## **REMARKS/ARGUMENTS**

In response to the Examiner's first Office Action of November 29, 2005 the Applicant respectfully submits the accompanying Terminal Disclaimer with respect to USSN 10/760,200, Amendment to the specification, drawings and claims, and the below Remarks directed thereto.

FIG. 43

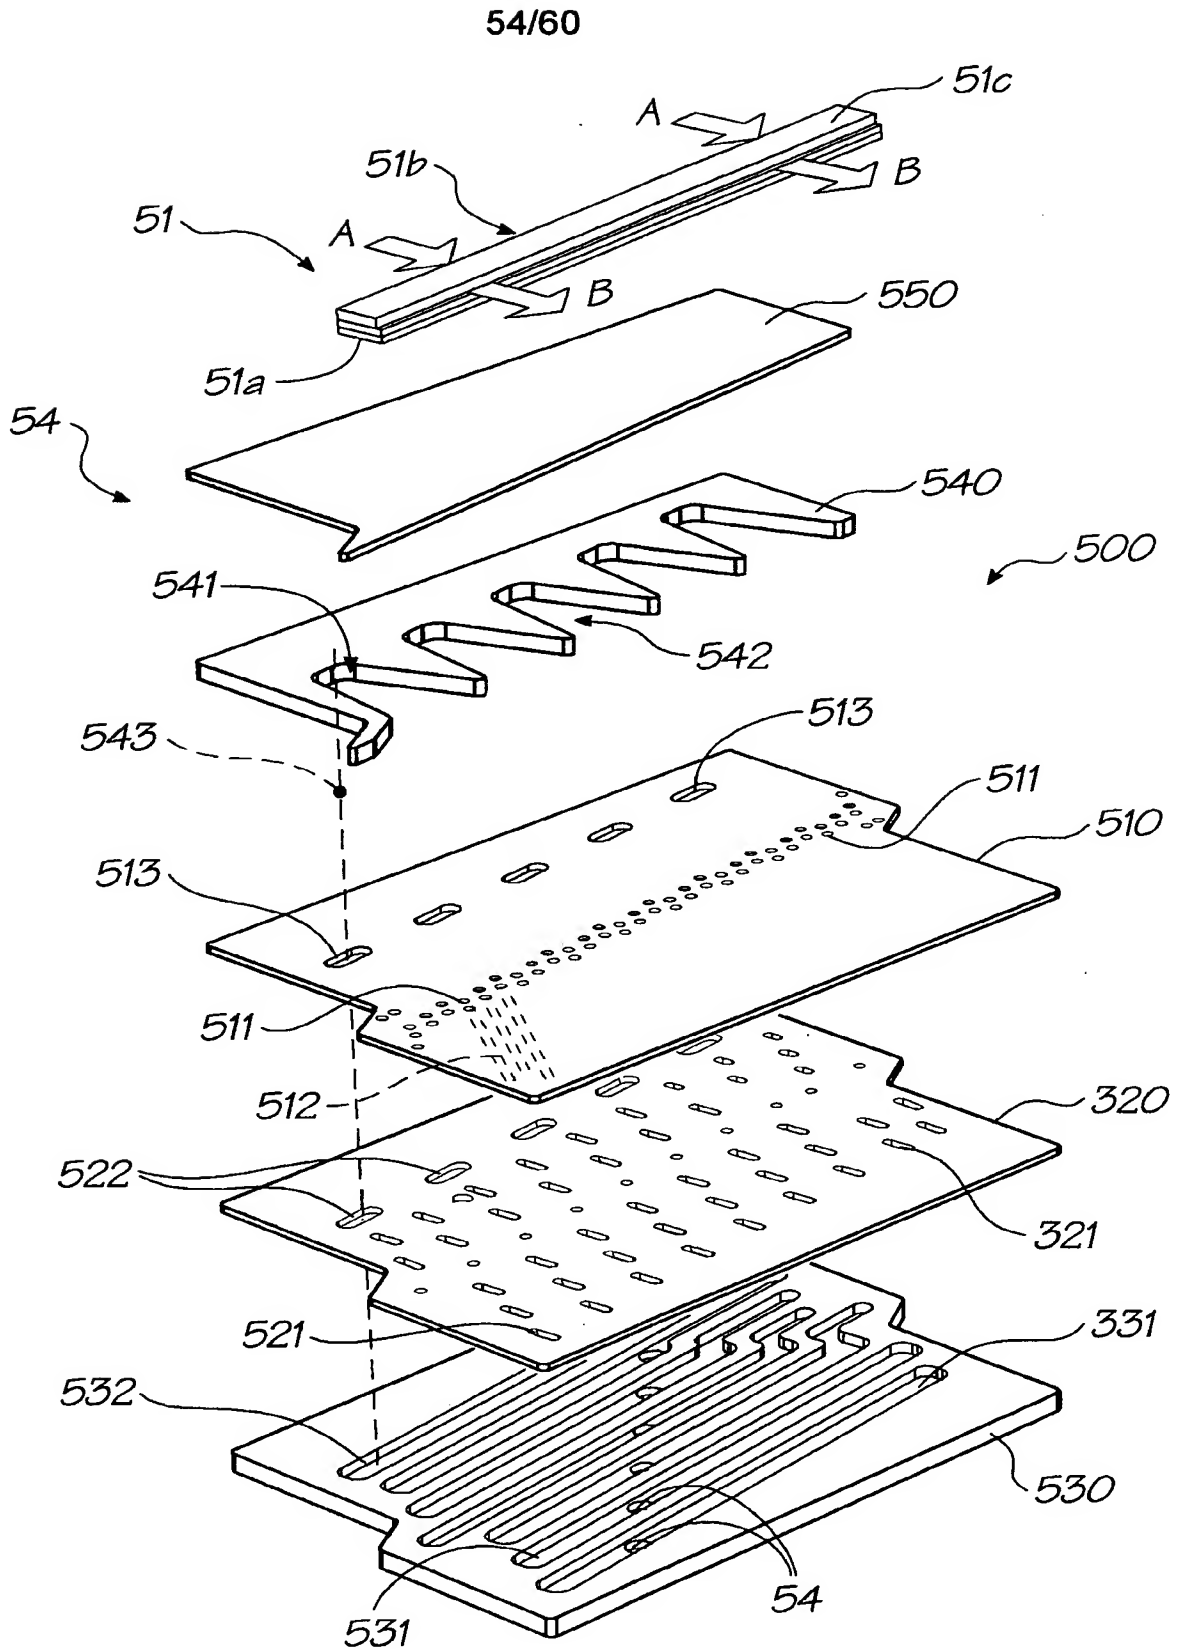
Fig. 43 is amended to include the reference sign "500", as is described at page 8, lines 23-31 of the present specification;

It is respectfully submitted that the above-described amendment to Fig. 43 to insert the reference sign "500", provides the correction required by the Examiner.

A corrected Fig. 43 is enclosed.
